# Access Compliance Report

## Public Rights-of-Way

Intersection ID: N/A	Main Street: ROCKY_RIVER_RD	Cross Street: JOHN_RUSSELL_RD	Location: SE
ADA ID: C836E31AD171	Ramp Type: Perp	Initial Pass/Fail: Fail	Overall Compliance: No
Severity Score: 22.5			
Codes/Mitigation Info/Possible Solution		Field Measurements/Component Compliance

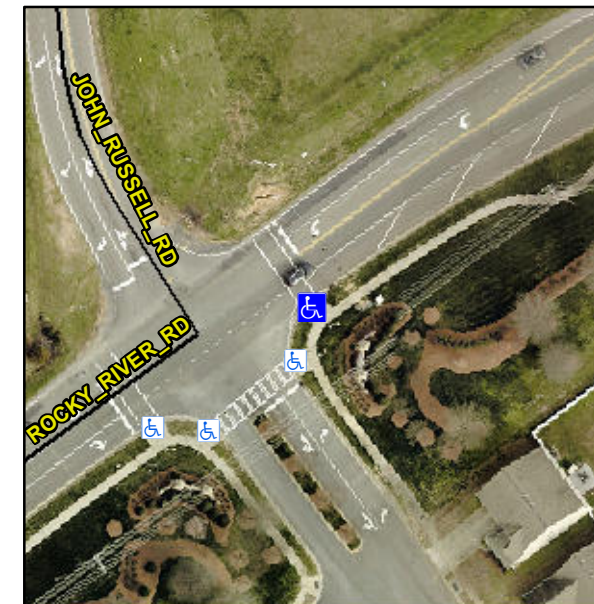
**Not Found, R304.5.1, R304.2.2, R304.5.3**

Compliance	Description	Data	Compliance	Description	Data
N/A	Ramp Length (in)	96.0	No	Ramp Slope (%)	9.4
No	Ramp Width (in)	46.0	No	Ramp XSlope (%)	3.1
N/A	Flare Type LT	N/A	N/A	Flare Type RT	N/A
N/A	Flare Slope LT (%)	N/A	N/A	Flare Slope RT (%)	N/A
N/A	Flare Traversable LT?	N/A	N/A	Flare Traversable RT?	N/A
N/A	Landing Length (in)	N/A	N/A	DWS Provided?	N/A
N/A	Landing Width (in)	N/A	N/A	DWS Contrast?	N/A
N/A	Landing Slope (%)	N/A	N/A	DWS Length (in)	N/A
N/A	Landing X Slope (%)	N/A	N/A	DWS Full Width?	N/A
N/A	Landing Curb? (Y/N)	N/A	N/A	DWS Offset (in)	N/A
N/A	Shared Landing?	N/A			
N/A	Gutter Ponding?	N/A	N/A	Gutter Slope (%)	N/A
N/A	Gutter Lip Ht (in)	N/A	N/A	Gutter X Slope (%)	N/A
N/A	Painted X Walk1?	Yes	N/A	Painted X Walk2?	N/A
	X Walk 1 Direction	To NW		X Walk 2 Direction	N/A
N/A	X Walk 1 Width (in)	110.0	N/A	X Walk 2 Width (in)	N/A
	X Walk 1 Slope (%)	3.6		X Walk 2 Slope (%)	N/A
	X Walk 1 X Slope (%)	1.2		X Walk 2 X Slope (%)	N/A

**Remove & Replace Entire Ramp.**
